Title
SolderingStation_Power.SchDoc

Size	Number	Revision
A4		3
Date:	8-21-2021	Sheet of
File:	Z:\Documents\..\SolderingStation_Power.SchDoc

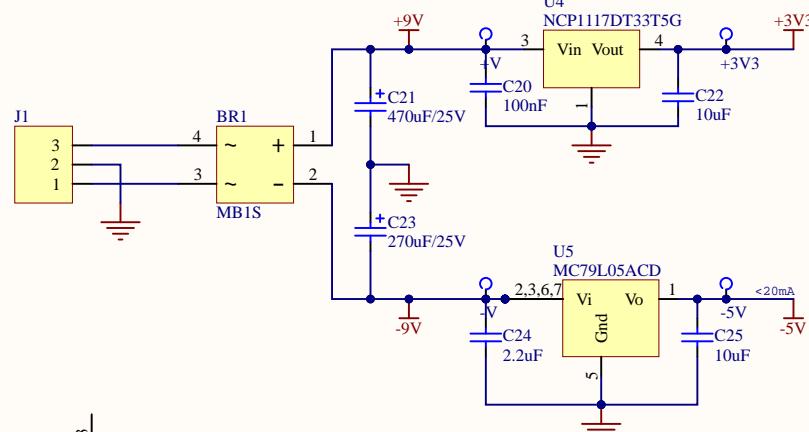
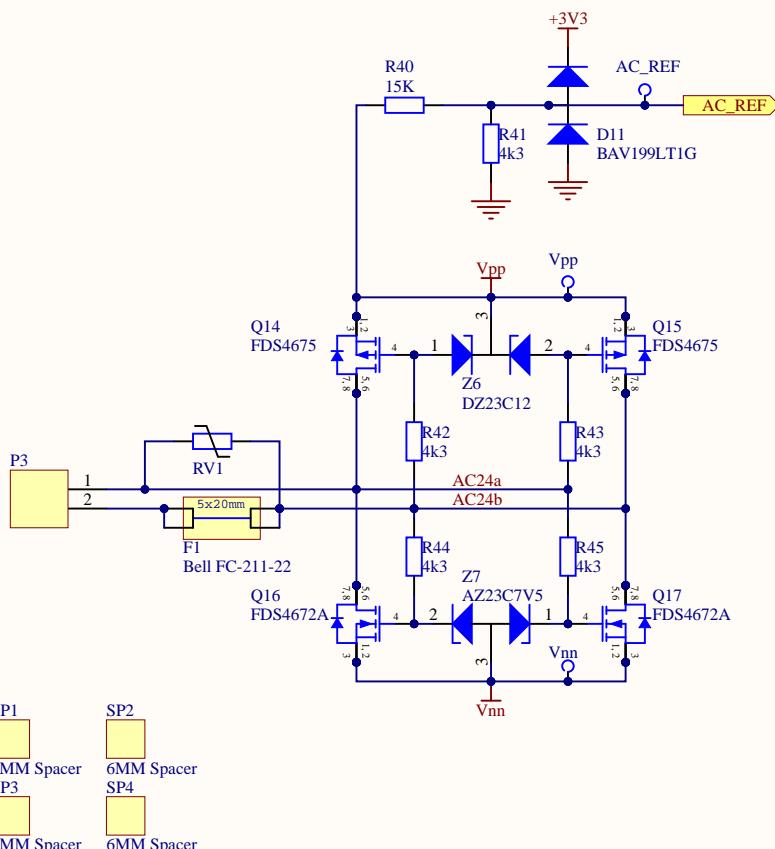
- Added Setback
- Changed current source IC etc.
- Added voltage reference for ADC

- Board Dimensions altered
- Simplified NTC cct. (linearity not required)
- Removed unused components
- Isolated USB
- Prevented TC amp saturating
- Power LEDs directly driven
- Overcurrent directly measured
- Decoupled 3V3 supplies (noise from OLED)
- Added MUX and lots of related changes
- Changed to 4 channels (2 pairs)
